**STATE OF TENNESSEE
DEPARTMENT OF TRANSPORTATION**

INSTRUCTIONAL BULLETIN NO. 15-13

Regarding Revised Standard Drawings

Effective Apr. 1, 2016 letting (Jan. 20, 2016 Turn-in), the following Standard Drawings have been revised. Section V of the Design Guidelines is revised to incorporate these changes.

STANDARD STEEL GROUND MOUNTED SIGNS, BREAK-AWAY TYPE POST FOOTING DETAILS, SQUARE TUBES

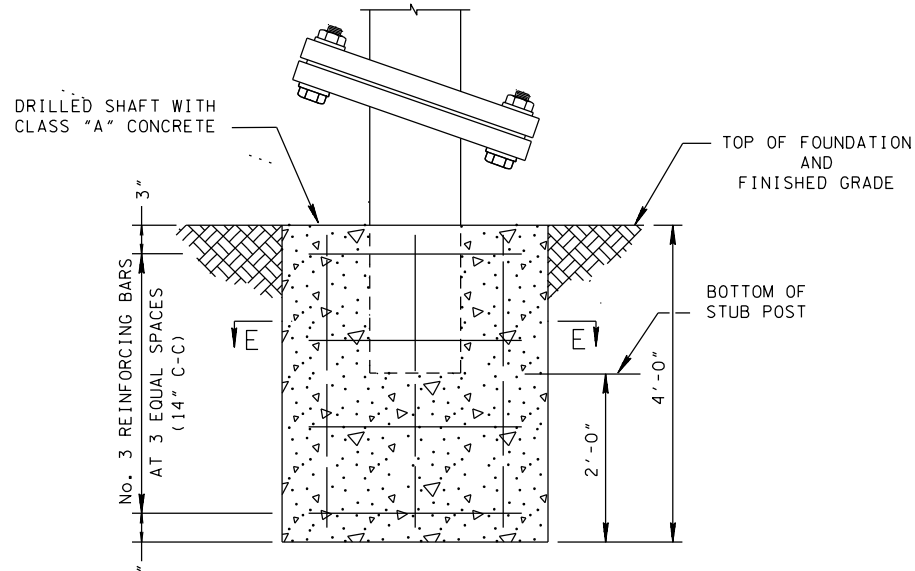
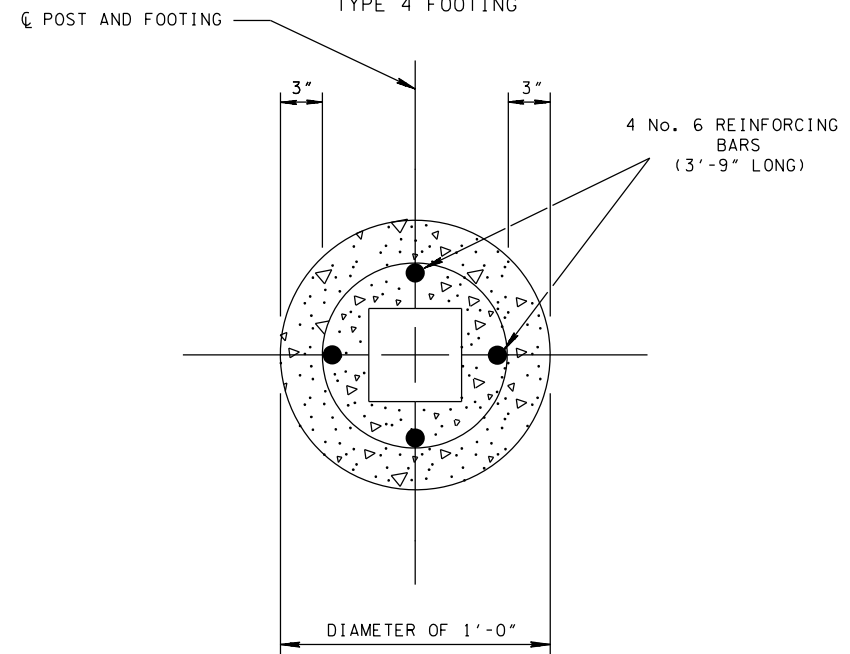
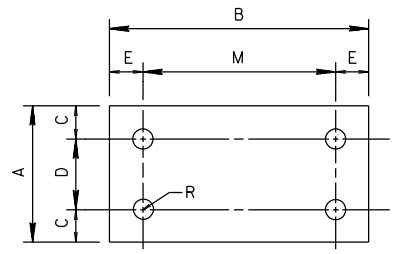
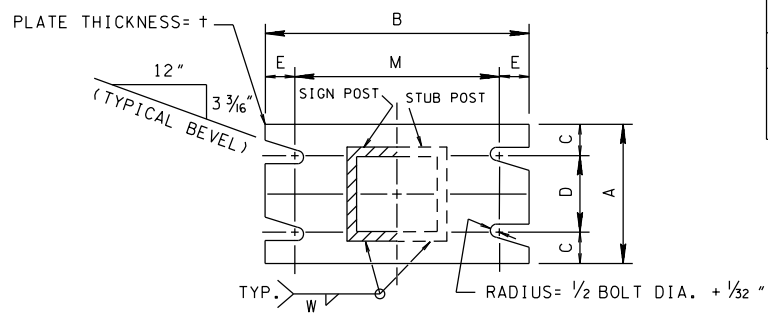
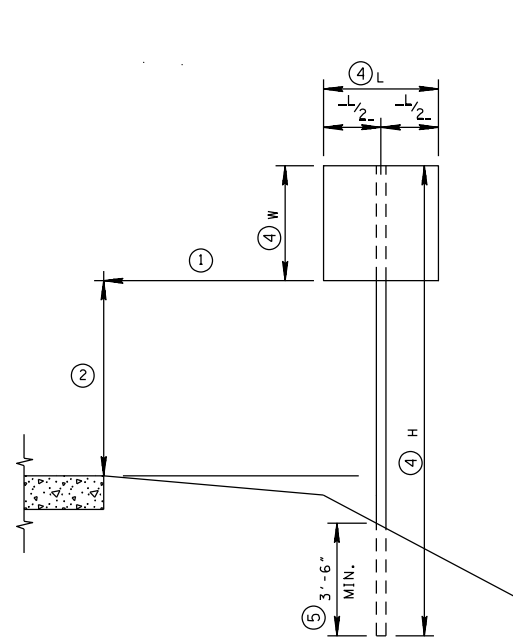
- REV. 10-26-96: CHANGED PAY ITEM NO. IN GENERAL NOTE (M).
- REV. 5-27-01: CHANGED NOTE UNDER SHIM DETAIL.
- REV. 5-27-03: CORRECTED GENERAL NOTE (E).
- REV. 7-2-15: REVISED TUBE SIZE. ADDED GENERAL NOTE (P).

GROUND MOUNTED
ROADSIDE
SIGN PLACEMENT
DETAILS

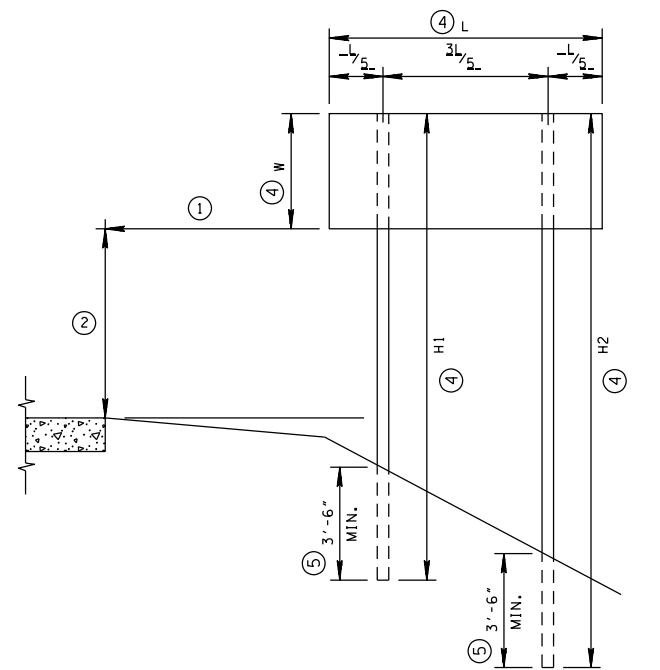
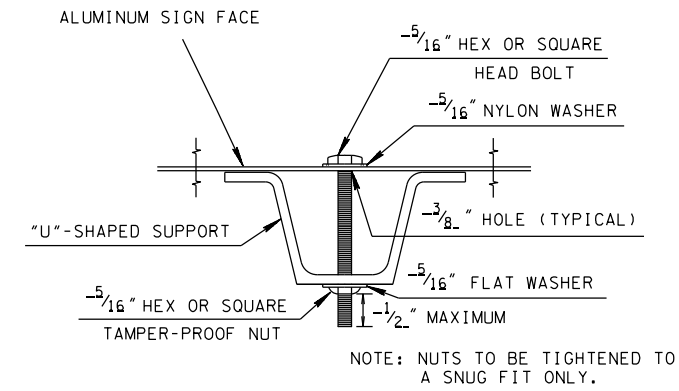
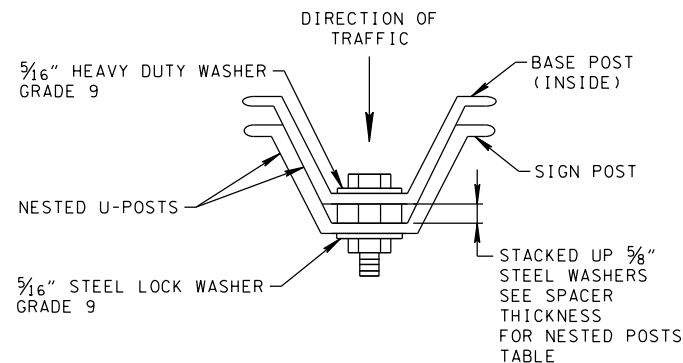
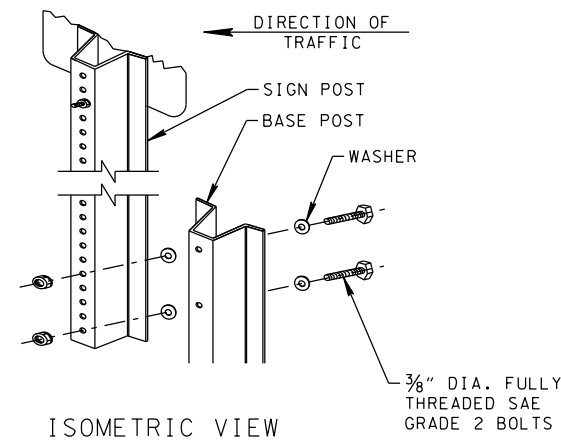
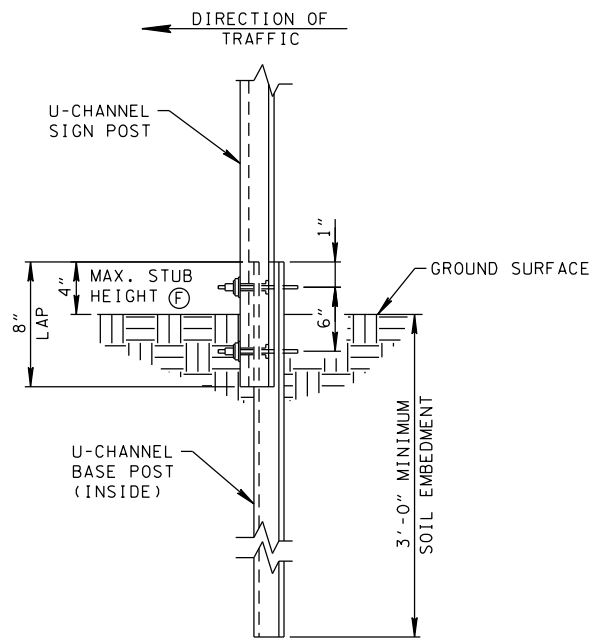
- REV. 11-1-11: REVISED GENERAL NOTES (A) AND (D). ADDED GENERAL NOTE (E). CHANGED R-15-2 SIGNS TO R15-2P.
- REV. 6-5-14: COMBINED T-S-16 AND T-S-16A.
- REV. 7-2-15: ADDED SINGLE DIRECTIONAL BREAKAWAY LAP SPLICE. ADDED FOOTNOTES (E).

GROUND MOUNTED
ROADSIDE
SIGN PLACEMENT
DETAILS

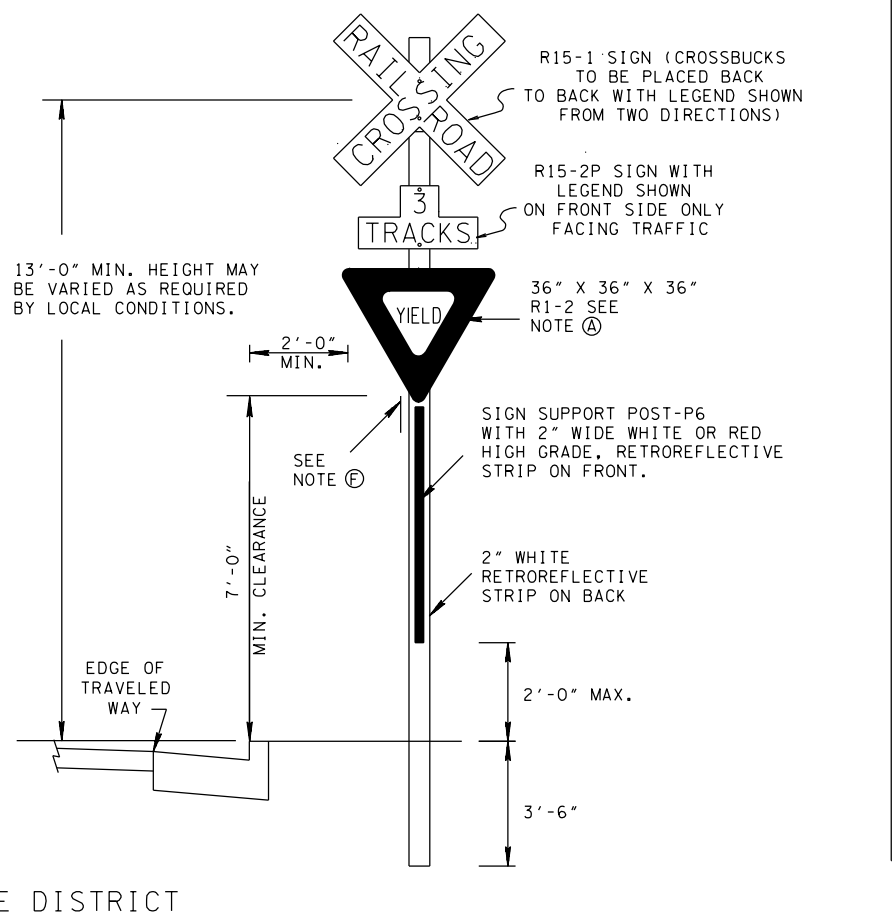
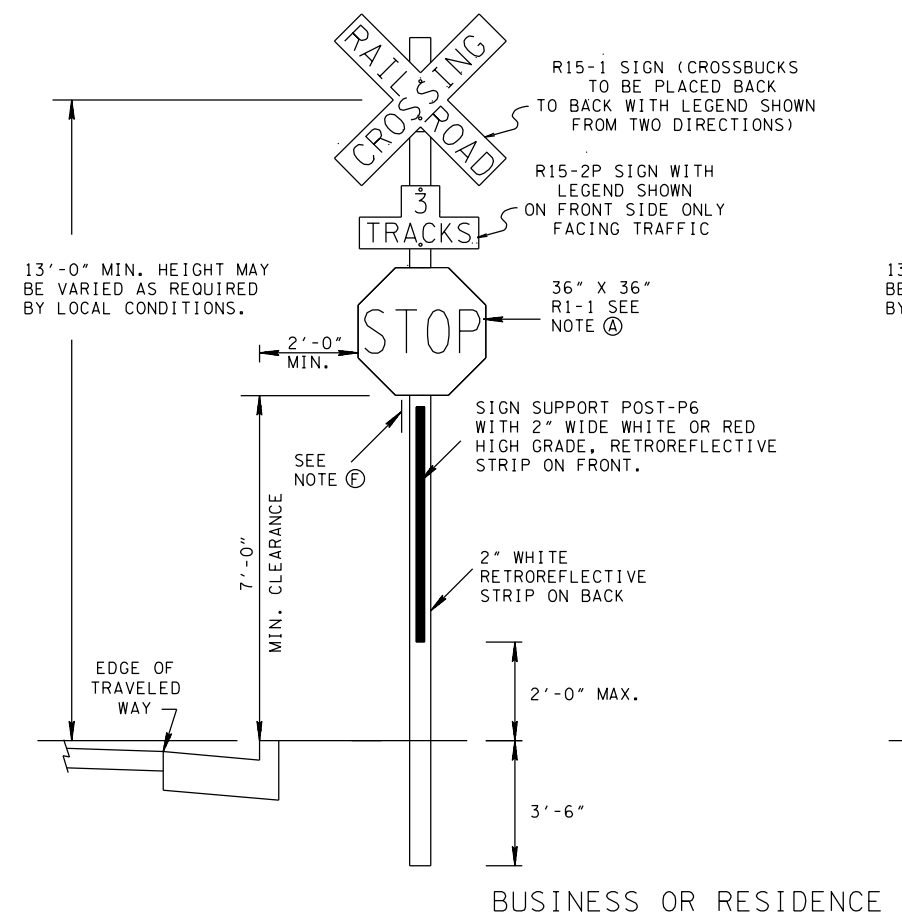
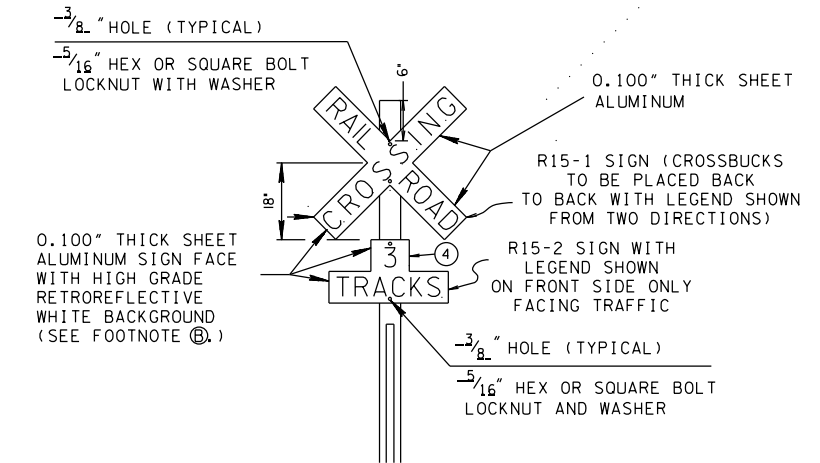
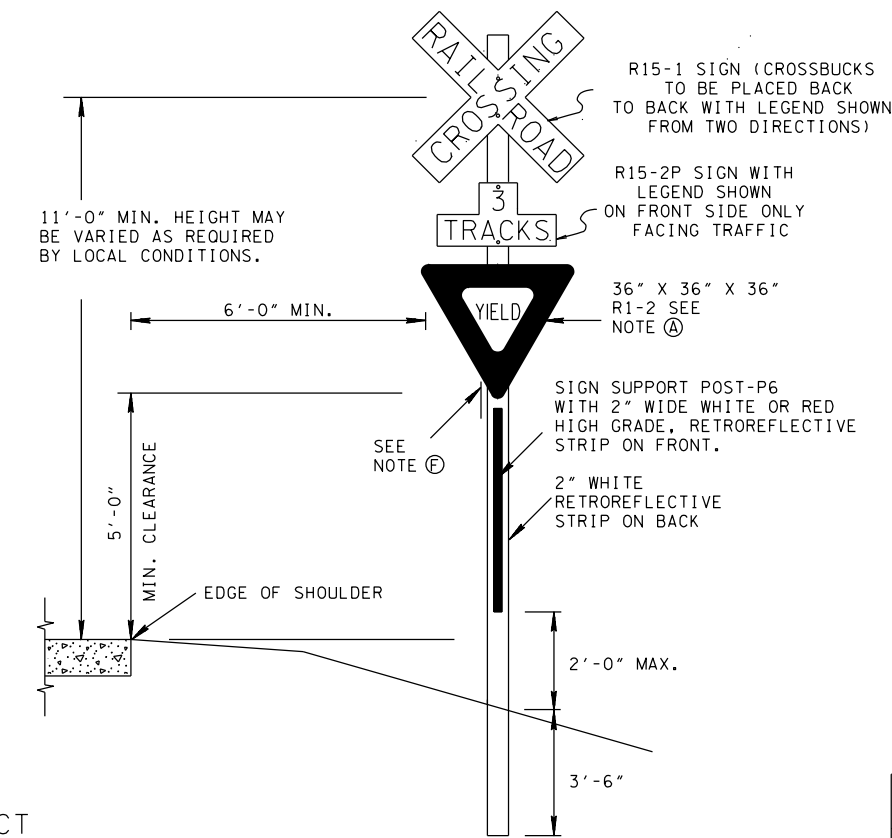
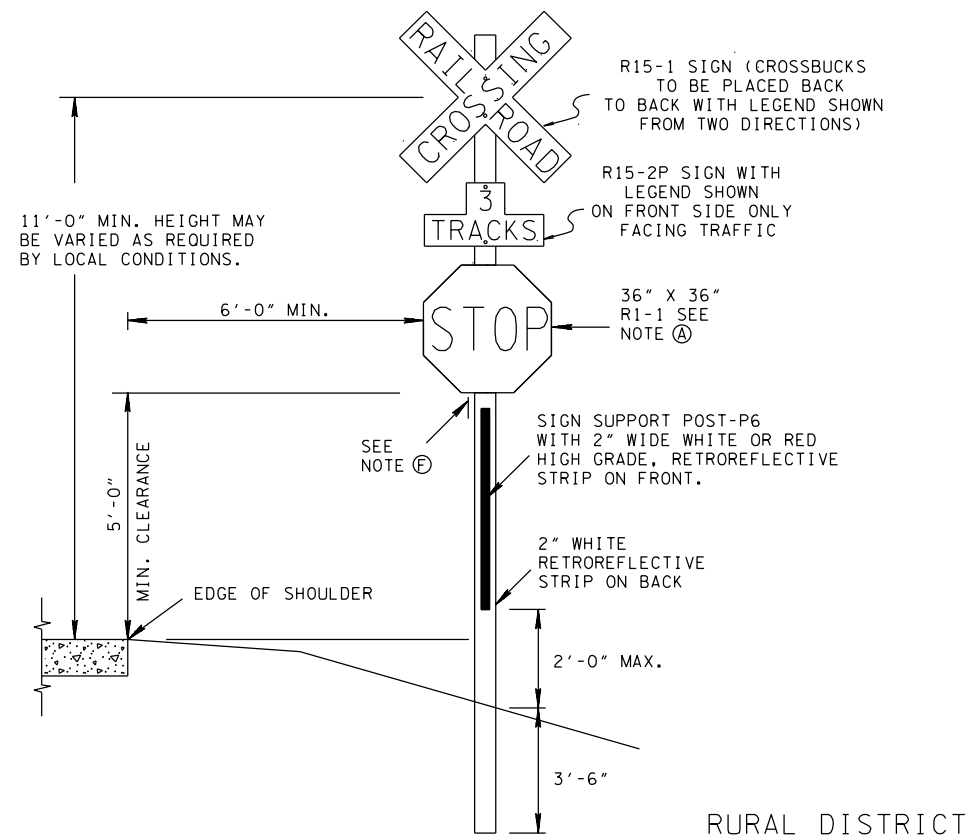
REV. 7-2-15: ADDED DETAILS. ADDED GENERAL NOTES (H).

DETAILS FOR SIGNS MOUNTS ON CONCRETE MEDIAN BARRIERS

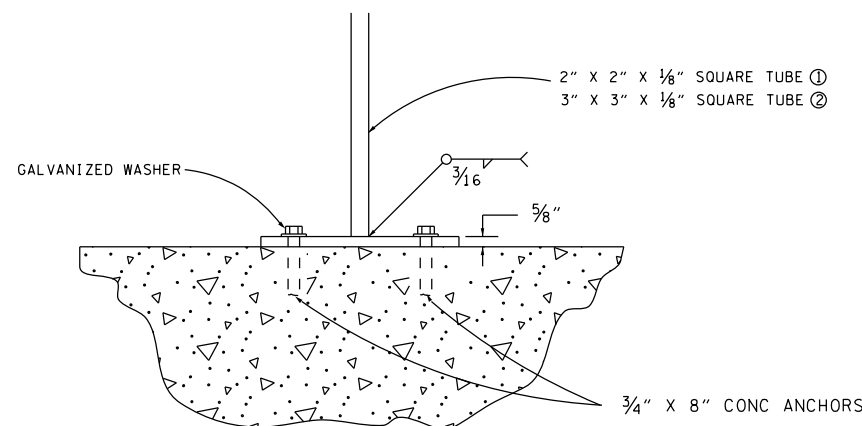
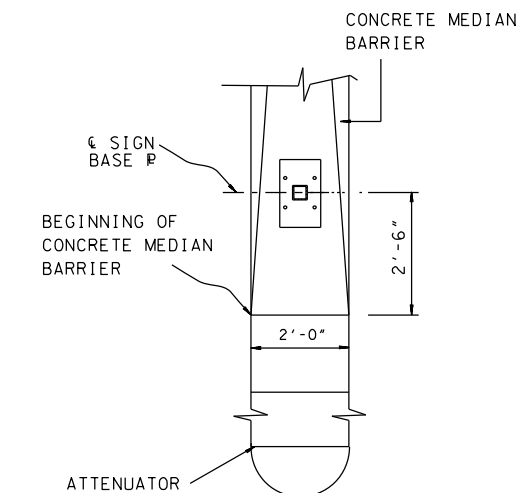
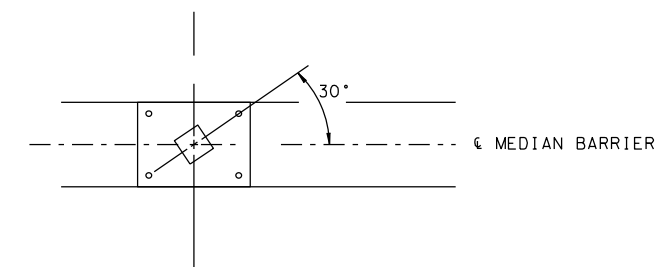
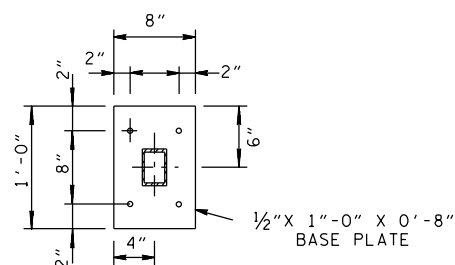
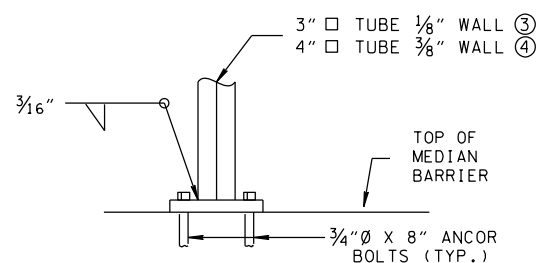
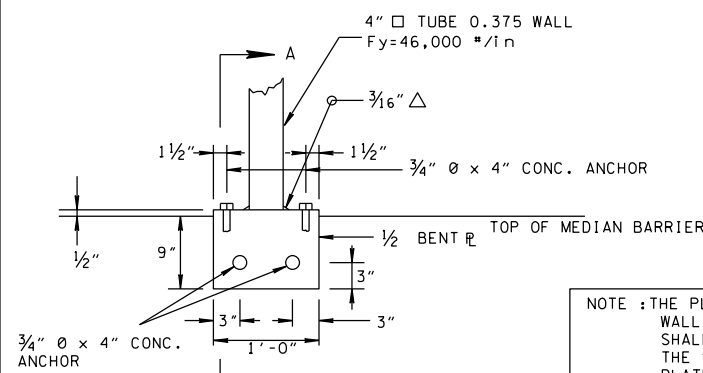
REV. 7-2-15: REVISED GENERAL NOTE ⑥

MULTI-DIRECTIONAL
SLIP BASE BREAKAWAY
P-POST
SIGN SUPPORT

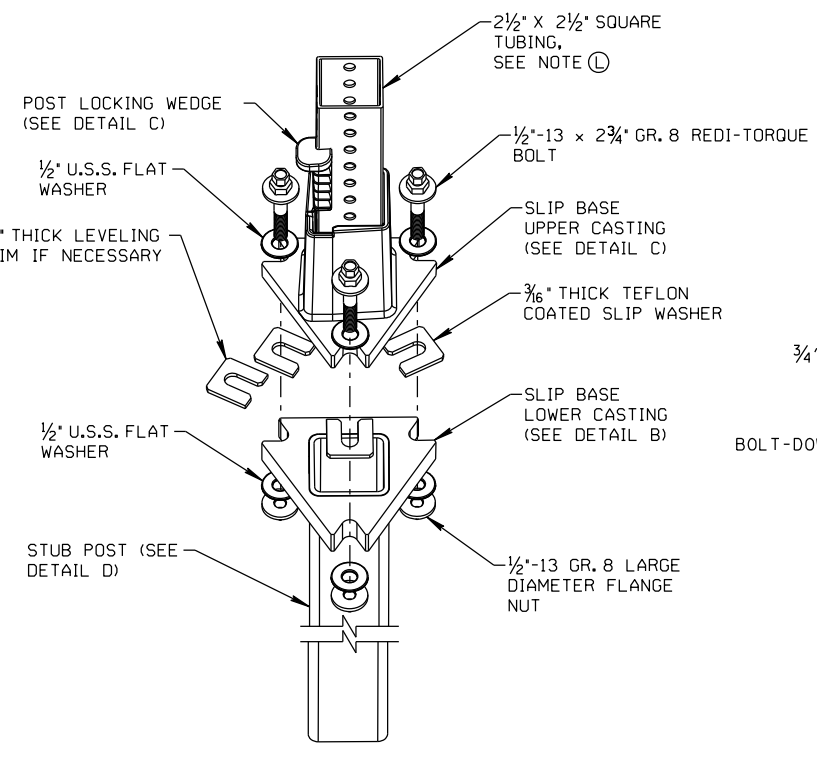
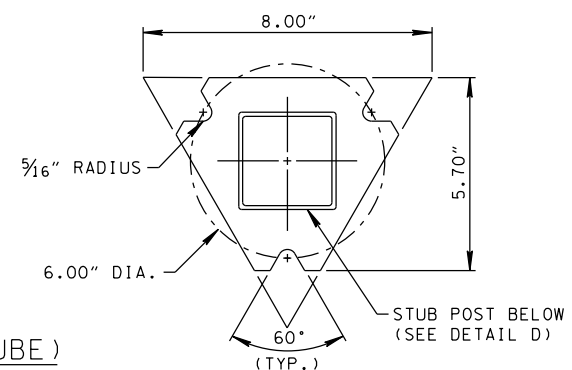
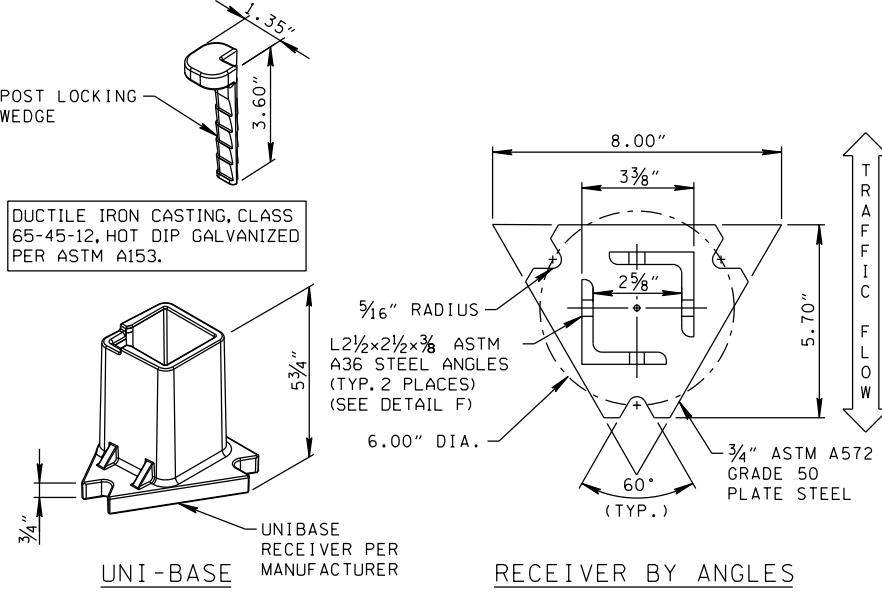
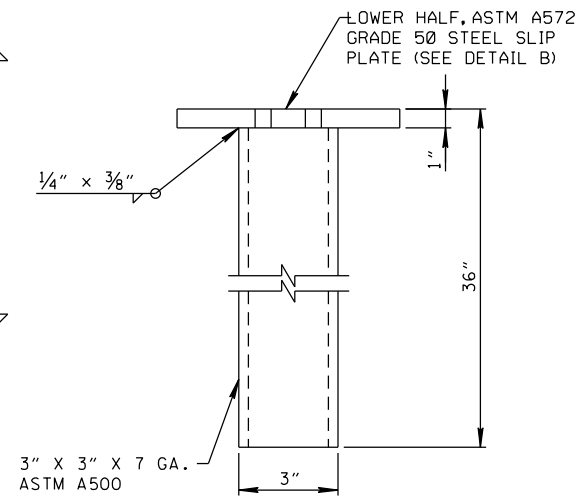
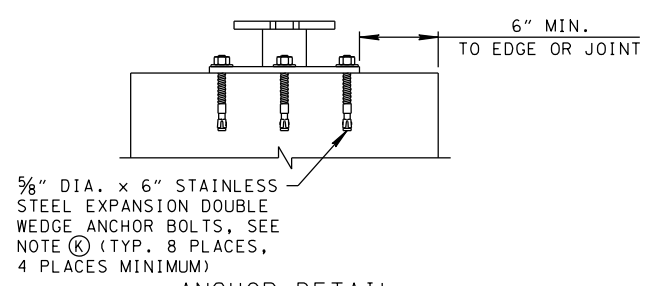
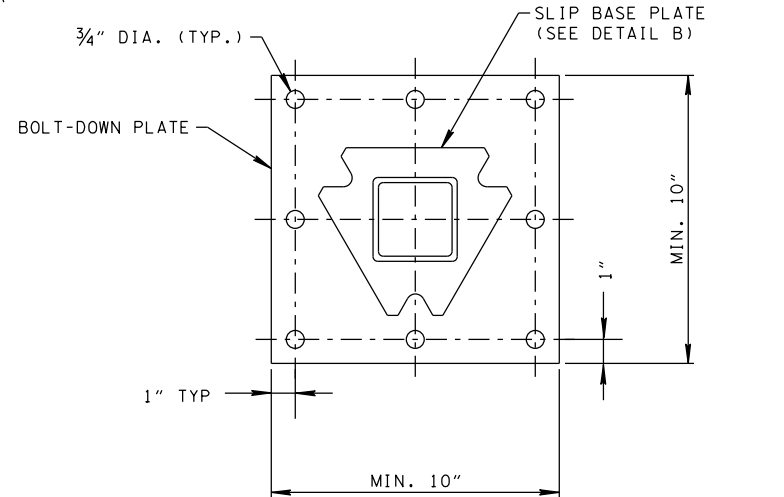
- REV. 7-19-13: ADDED NOTE (N). MINOR EDITS TO DRAWINGS. MODIFIED NOTE (M).
- REV. 8-25-14: REVISED NOTE (H).
- REV. 7-2-15: REVISED GENERAL NOTES AND FOUNDATION DETAILS.
